**SECOND
GENERATION
DISTRICT PLAN**

**Natural Environment
Decision of Hearings Panel**

**Proposed Second Generation Dunedin City
District Plan (2GP)**

7 November 2018

Figure 3: ASBV C163 – Alexanders Creek

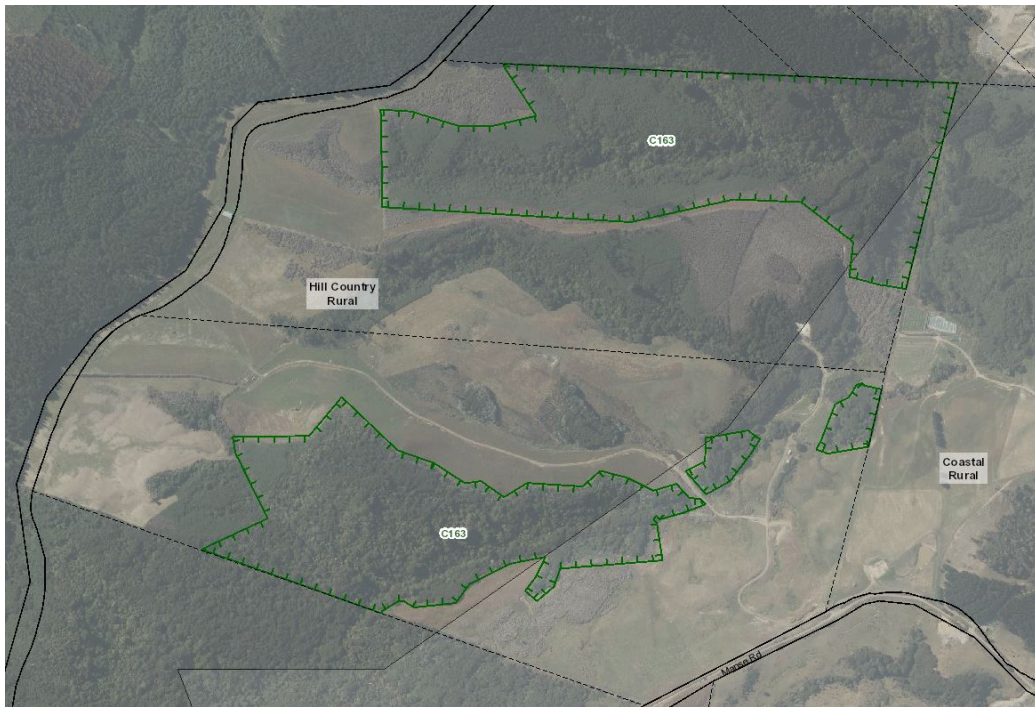
592. We accept in part the submission of the *Department of Conservation* (OS949.21) and have added two new areas to the ASBV schedule.
593. Noting that the area has been previously been assessed as significant by ecological consultants, that the landowner at 640 Portobello Road is supportive of the area in his ownership becoming an ASBV, we support the inclusion of new ASBV C164 Grassy Point in the 2GP, as recommended by the Reporting Officer.

595. In response to this submission, we have therefore added ASBV C163 Alexanders Creek and C164 Grassy Point to the planning maps and to Appendix A1.2 as follows:

Figure 5: ASBV C104 and UBMA at Doctors Point

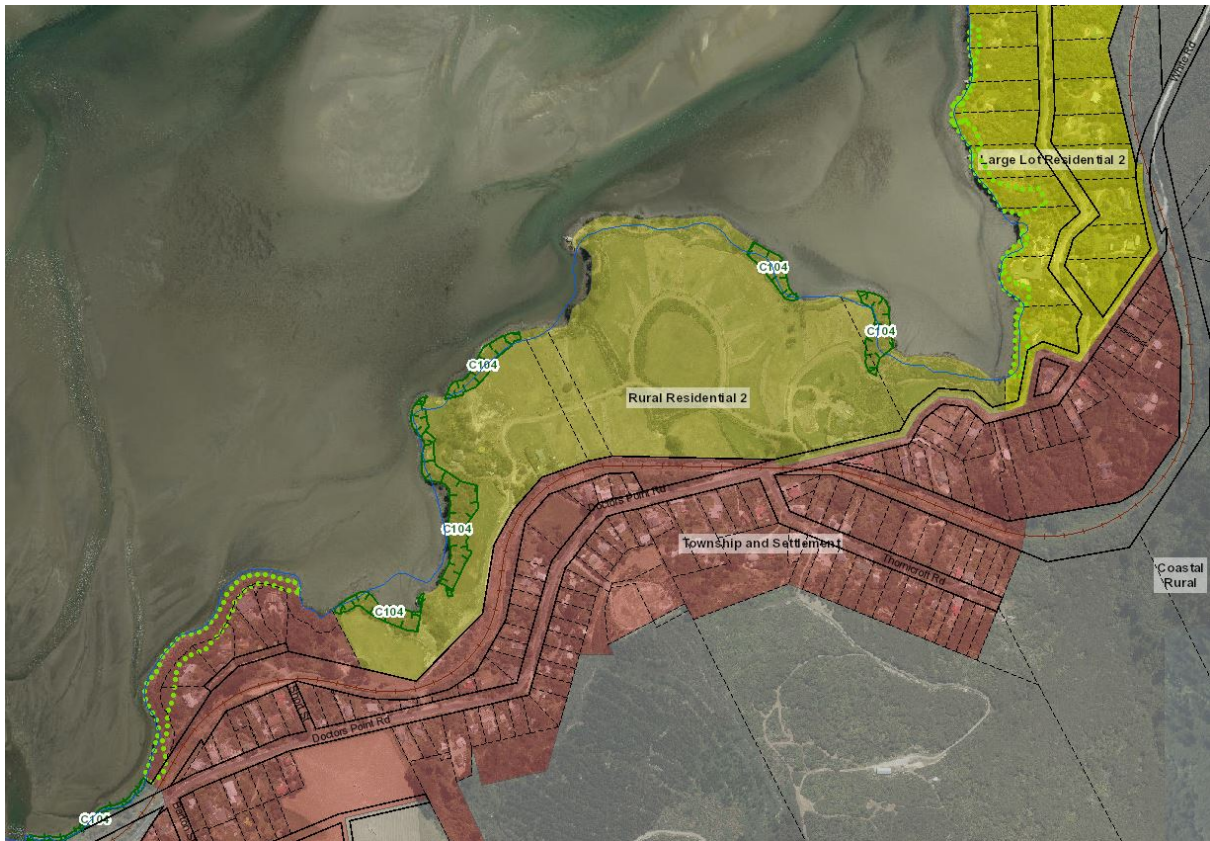
607. Figure 5 below shows where we have reinstated ASBV C104 within the new Rural Residential 2 zoning at Doctors Point, along with the new Doctors Point UBMA as bounded by the dotted green line within the Township and Settlement and Large Lot Residential 2 zones.

Figure 11: Esplanade Reserves and Strips Mapped Area at Brookside Place

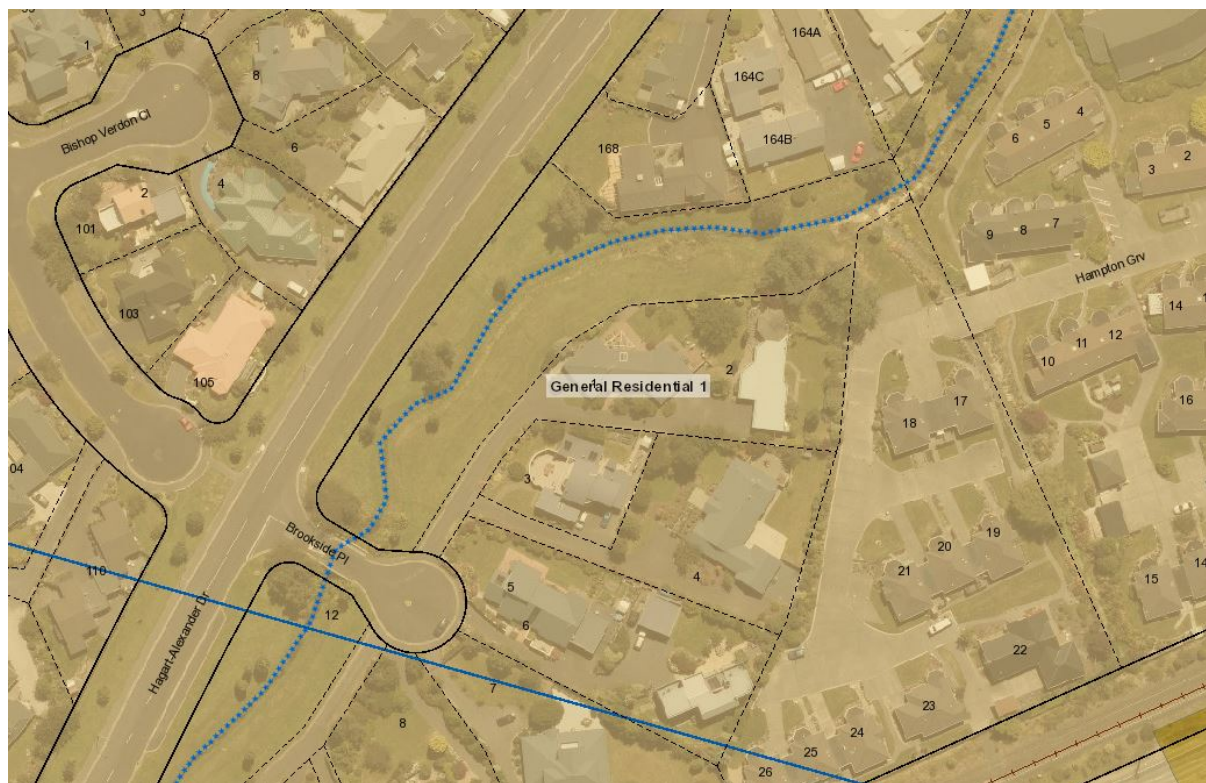
2409. We accept the submission of *Bill Feather* (OS475.2) to amend the mapping of the Esplanade Reserves and Strips Mapped Area in the vicinity of 1 Brookside Place, Mosgiel. We accept the evidence of the Reporting Officer that this has been incorrectly mapped in relation to the bed of the Owhiro Stream.
2410. In response to the submission of *Bill Feather* (OS475.2), we have therefore amended the mapping of the Esplanade Reserves and Strips Mapped Area in the vicinity of 1 Brookside Place, Mosgiel as shown in Figure 11 below.

Figure 13: Heyward Coast ONL

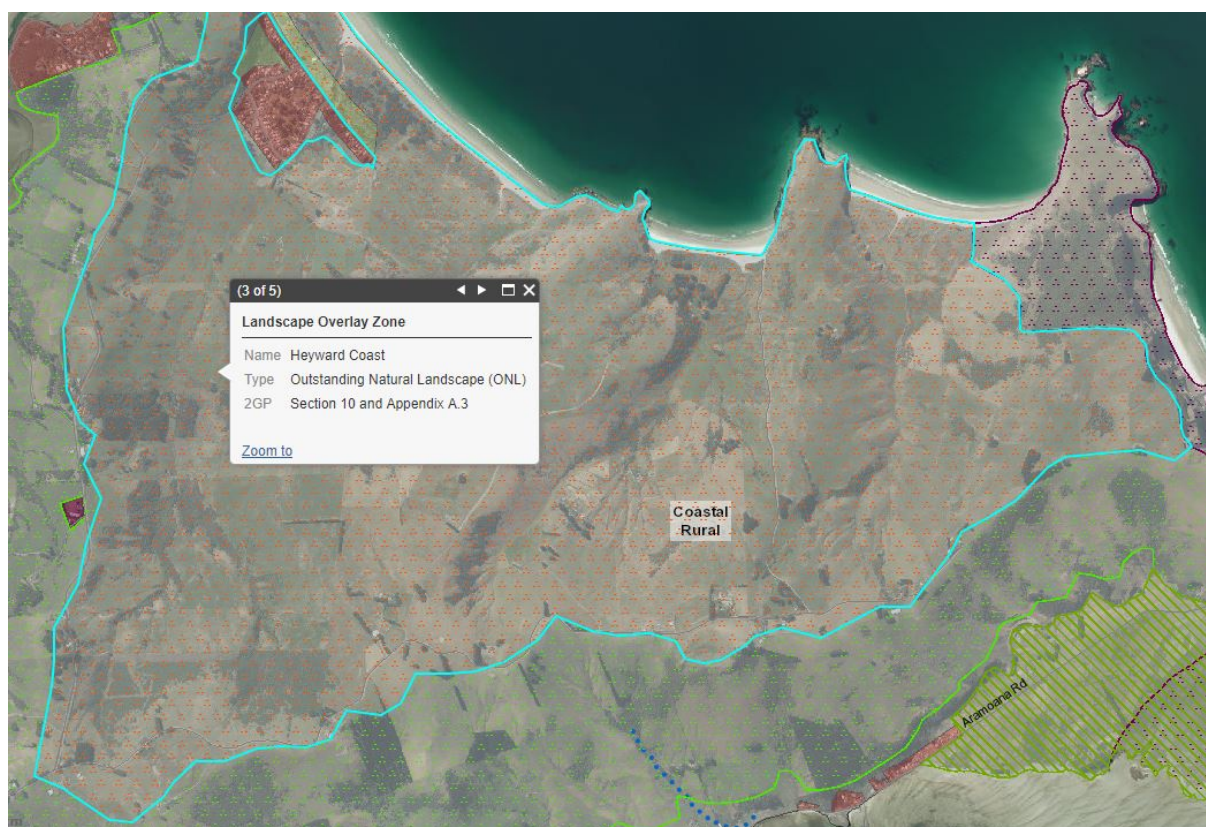
2746. We accept the evidence of Mr Moore that the Heyward Coast portion of the suggested West Harbour ONL does indeed hold values consistent with outstanding natural landscape status, but that the remaining (Harbour-facing) area of the suggested West Harbour ONL is too modified and variable in quality to qualify as an Outstanding Natural Landscape.

Figure 14: Flagstaff-Mt Cargill SNL at Waitati Valley

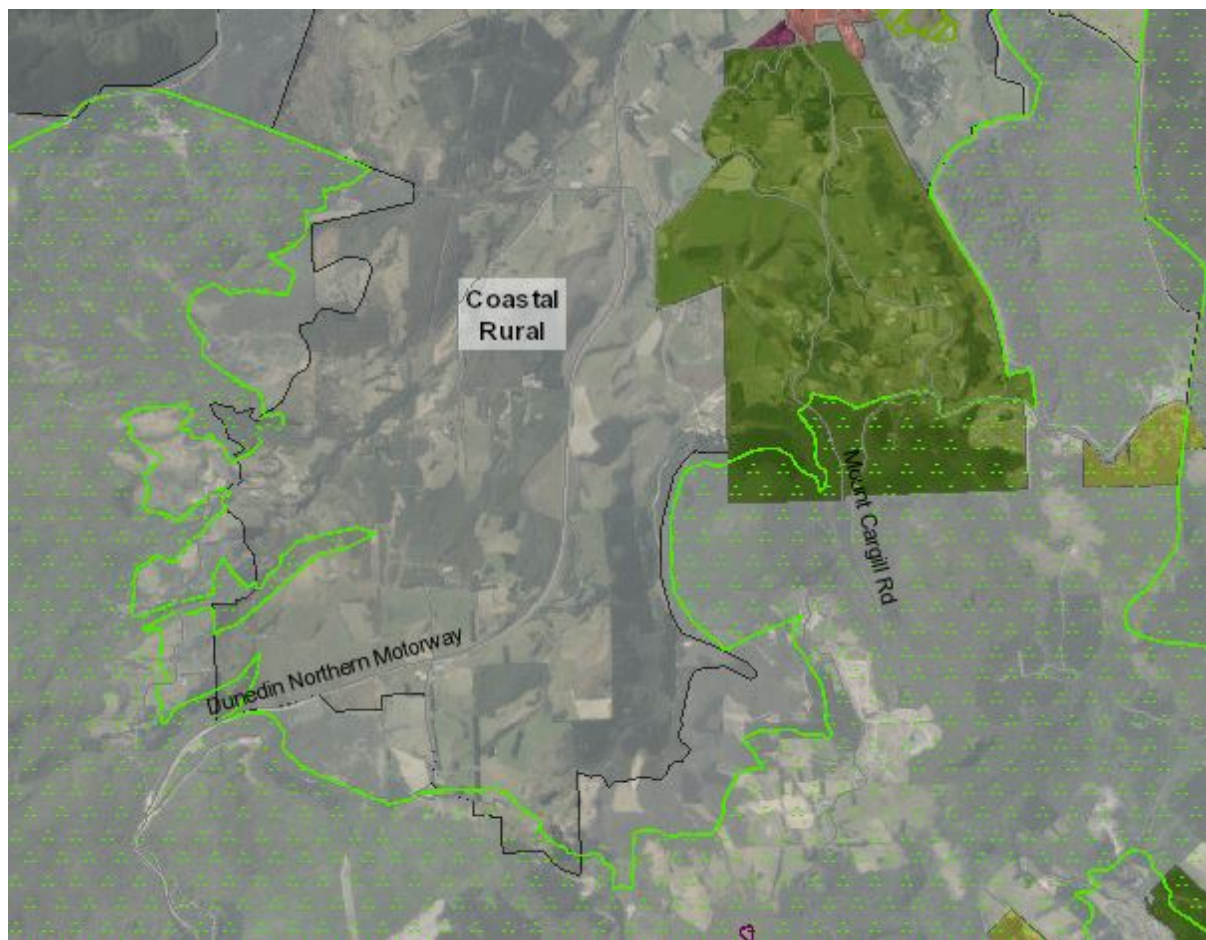
2803. In relation to the submission of *Blackhead Quarries Ltd* (OS874.53), we rely on the evidence of Mr Moore that this property is most appropriately retained within the SNL overlay zone.
2804. While we consider there is scope to extend the SNL overlay zone to include the mid-valley bush area around Fergusons Creek identified by Mr Forsyth as a possible addition, we were not convinced that there were strong landscape reasons to do so.
2805. The amended mapping of the Flagstaff-Mt Cargill SNL in the upper Waitati Valley is shown in Figure 14 below. This figure shows the SNL at a very broad scale, and we suggest that Plan users will need to consult the 2GP maps to ascertain the mapping of the SNL at an individual property level.

Figure 15: Flagstaff-Mt Cargill SNL at Norwood Street

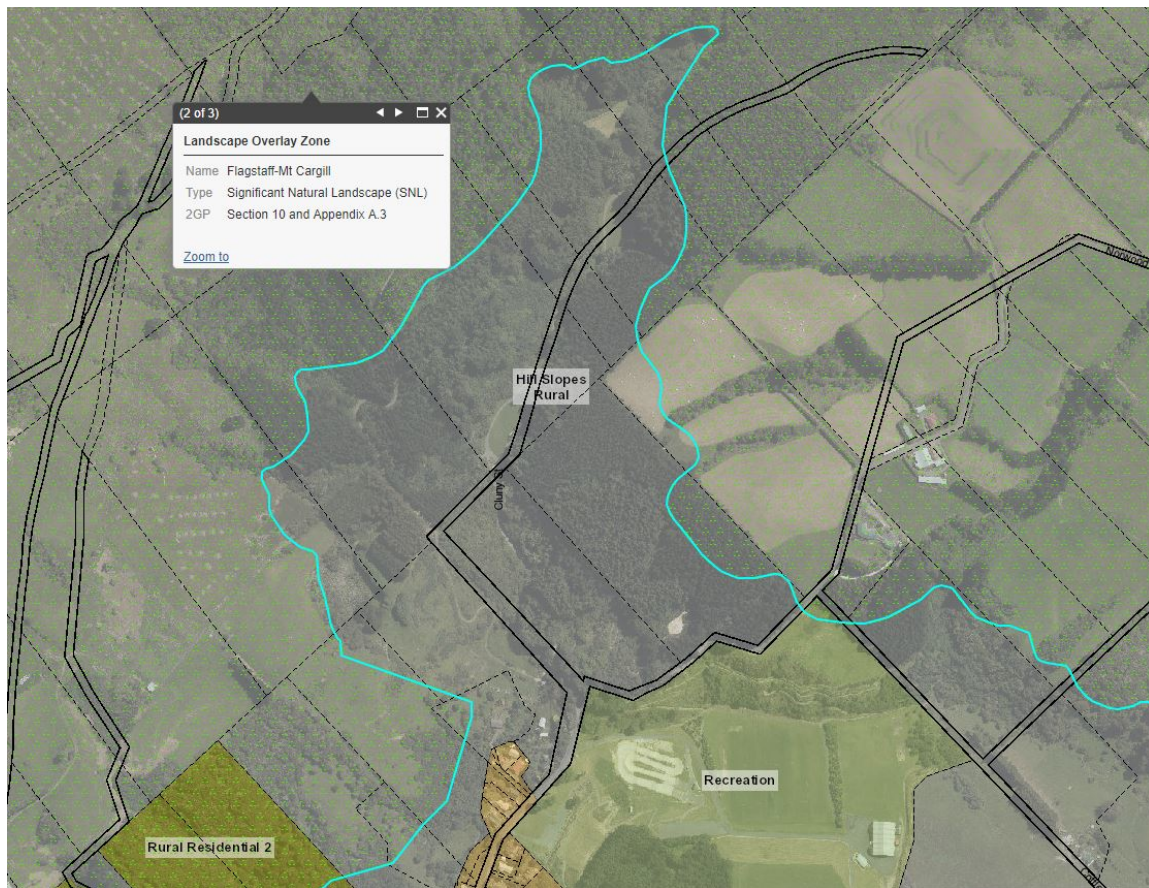
2819. The amended mapping of Flagstaff-Mt Cargill SNL in the vicinity of 191 Norwood Street is shown in Figure 15 below.

Figure 16: North West Peninsula SNL at 656-650 Portobello Road

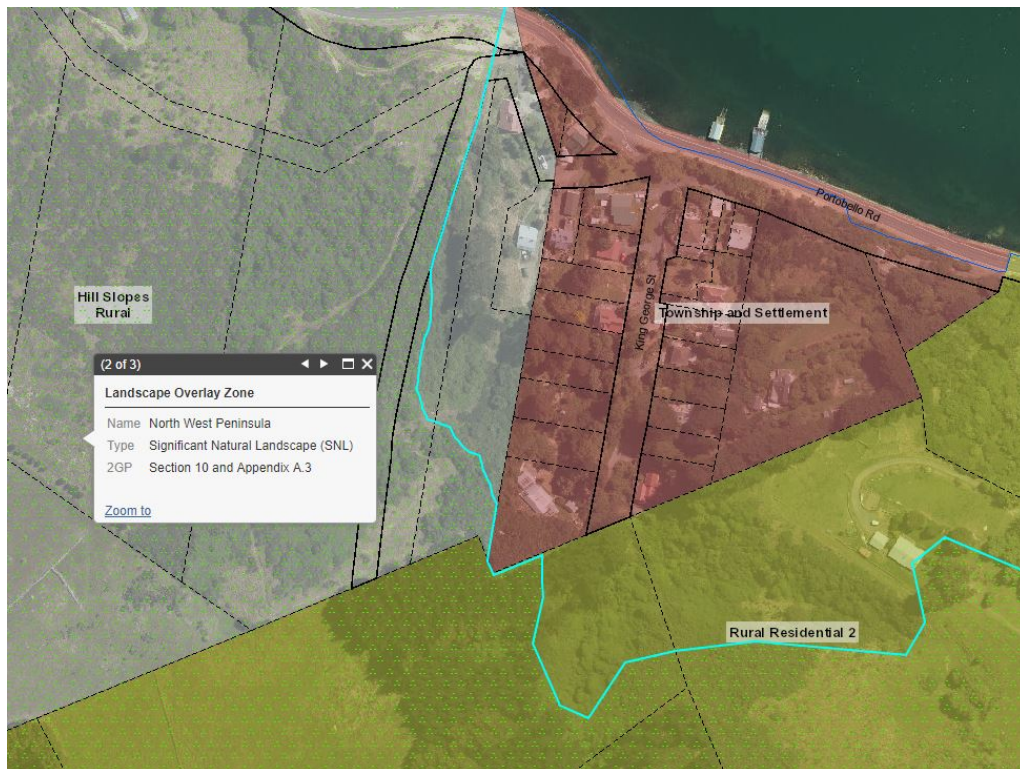
2837. Our decision is therefore to accept the submission of *Philip and Shakuntala Cunningham* (OS965.2) to remove the North-West Peninsula SNL overlay zone from 457 Highcliff Road.
2838. The amended mapping of the North West Peninsula SNL in the vicinity of 457 Highcliff Road is shown in Figure 17 below.

Figure 18: Silverpeaks SNL – northern and north-western extents

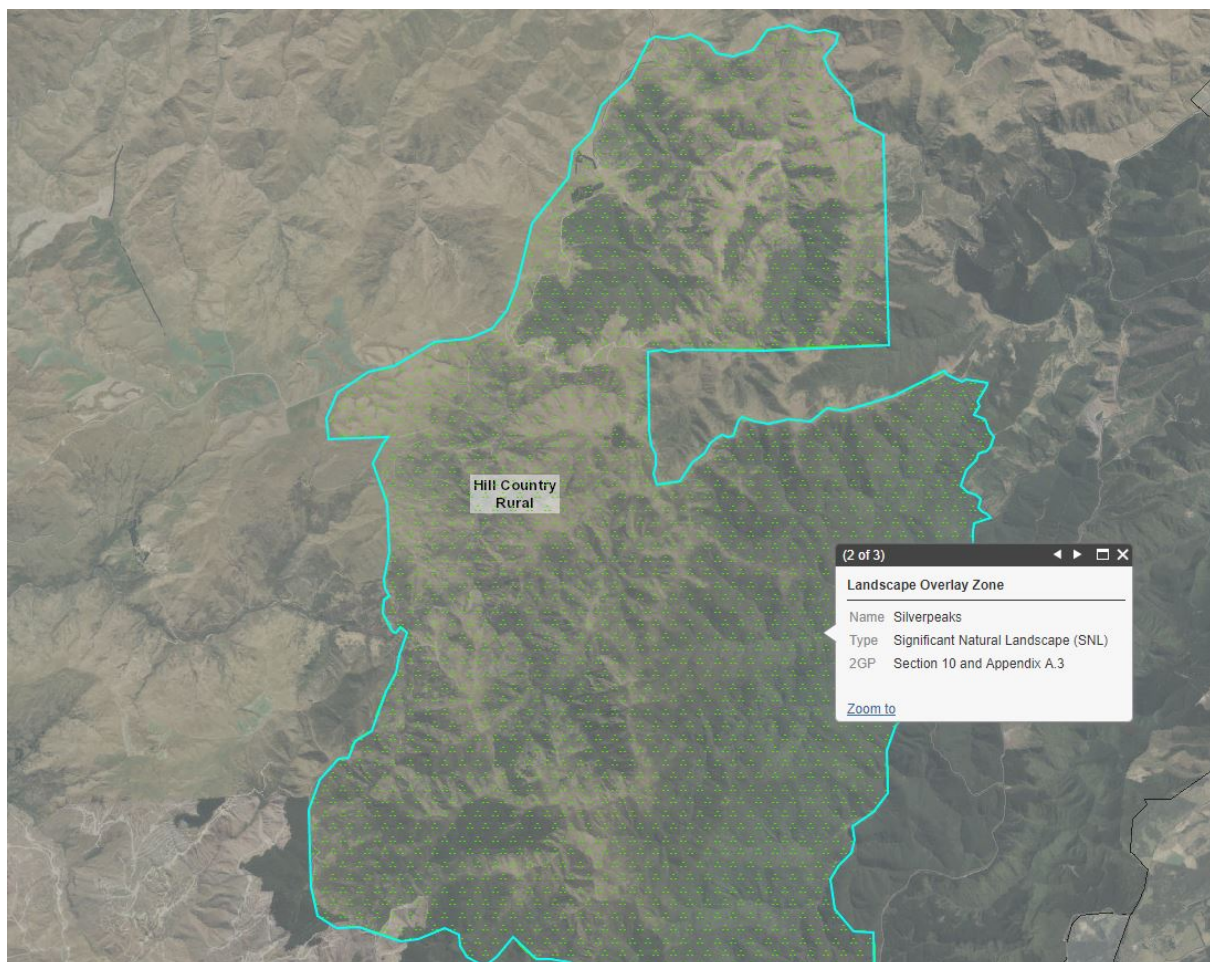
2894. Forestry is subject to a restricted discretionary resource consent in SNLs, however as outlined in section 3.7 of this Decision Report, our decision incorporates an alternative policy test for discretionary and restricted discretionary activities in SNLs, recognising situations in which there are “no alternative practicable locations” with a lower bar “alternatively mitigated” policy test.
2895. Overall, we consider the evidence suggests there are areas of 262 Silverpeak Road that have values that warrant protection (by way of the retention of the Silverpeaks SNL zone), and that any imposition this overlay zone may cause to the landowner is not substantial enough to warrant its removal on this basis. Having considered all the evidence, on balance, we consider the SNL overlay zone can be reduced over this property, but only to the extent supported by the final evidence of Mr Moore.
2896. Our decision has therefore amended within scope the northern and north-western boundaries of the Silverpeaks SNL overlay zones. This amended mapping is shown in Figure 18 below. This figure shows the SNL at a very broad scale, and we suggest that Plan users will need to consult the 2GP maps to ascertain the mapping of the SNL at an individual property level.

Figure 21: Blueskin Bay NCC at McLachlan Street

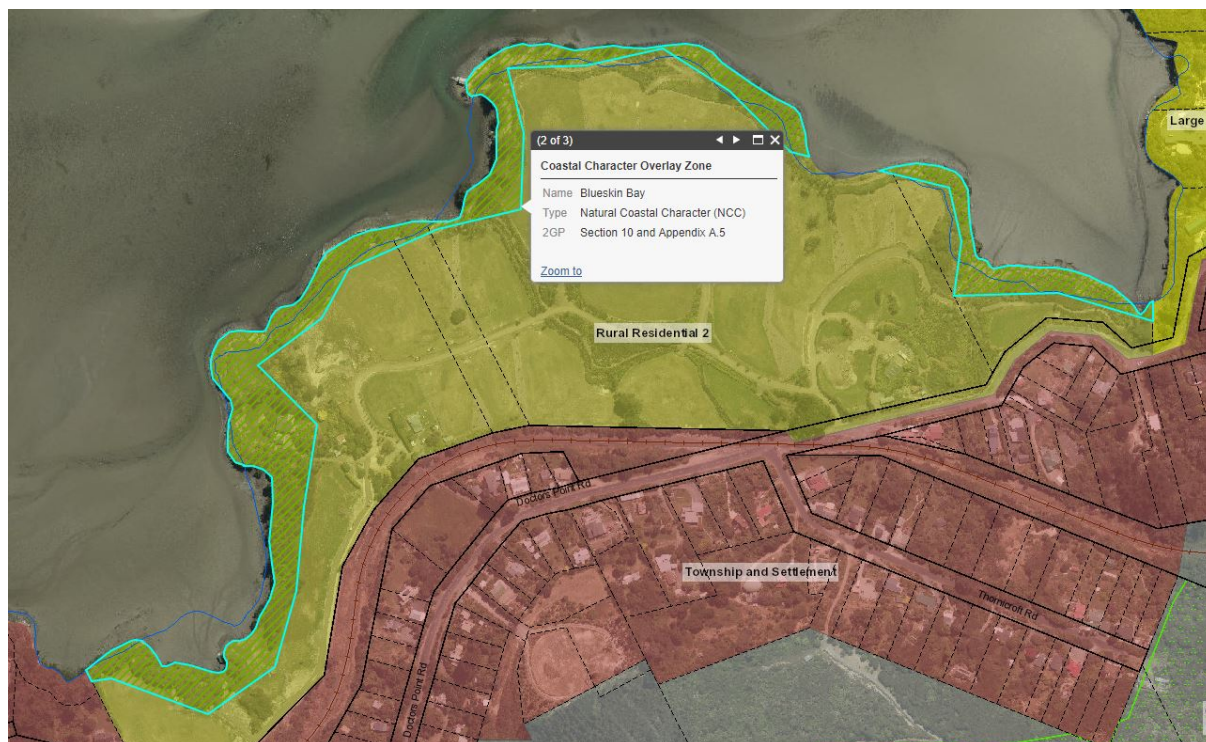
2998. The amended mapping of the Blueskin Bay NCC overlay zone in response to the submission of *Mark Thom* is shown in Figure 21, while the amended mapping of the Blueskin Bay NCC overlay zone in response to the submissions of *John Kaiser*, *Murray Johnston* and *Wendy Harrex* is shown in Figure 22 below.

Figure 24: Waikouaiti Estuary NCC at Merton Station Road

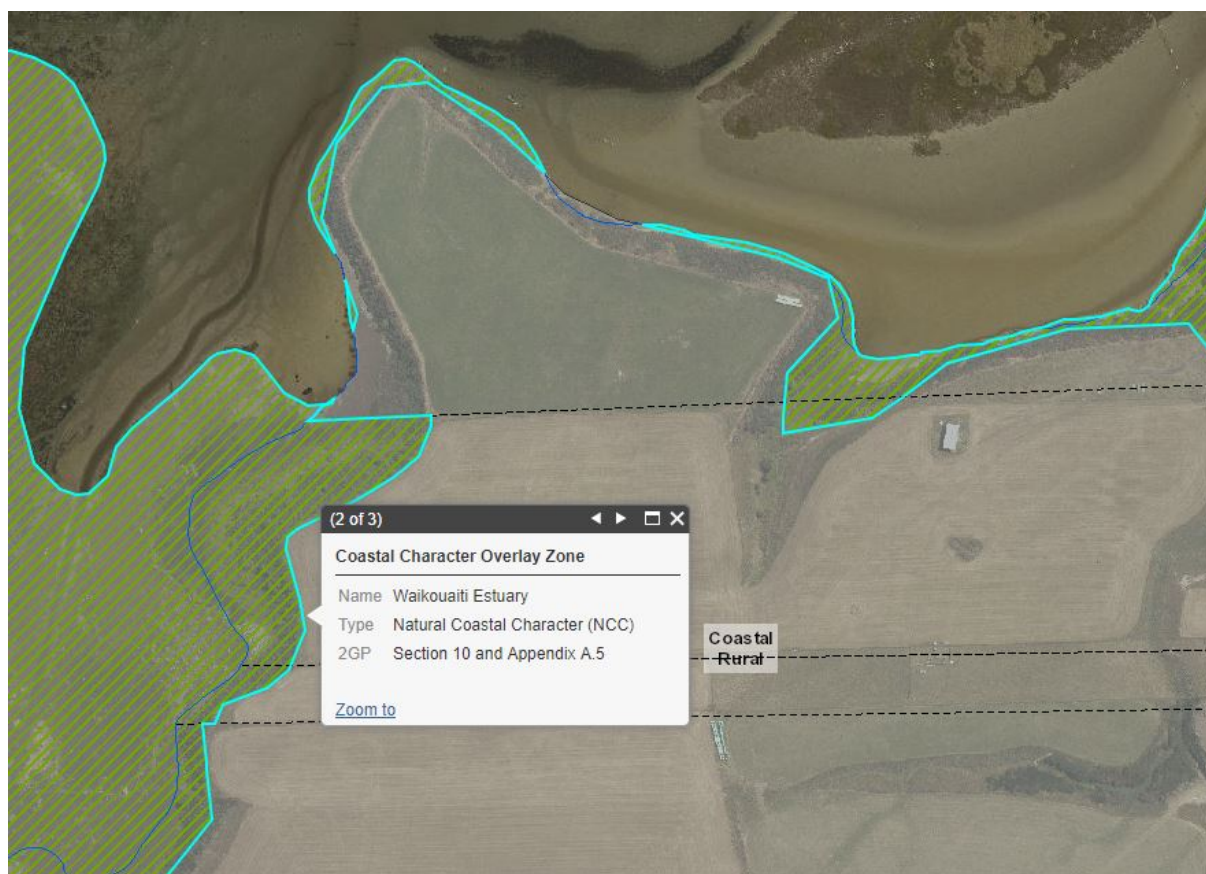
3013. This submission is one of a number that have raised questions about the accuracy of the mapping in the notified 2GP. We do not consider that we have scope in submissions to make general improvements to the quality of the mapping, as it would have implications for notified boundaries, but we highlight the issue for consideration as part of a future Plan review process. We recommend that this review pays particular attention to the position of Mean High Water Springs, as it appears in some cases (including at 40 and 50 Merton Station Road) the 2GP has mapped overlay zones outside of its jurisdiction.
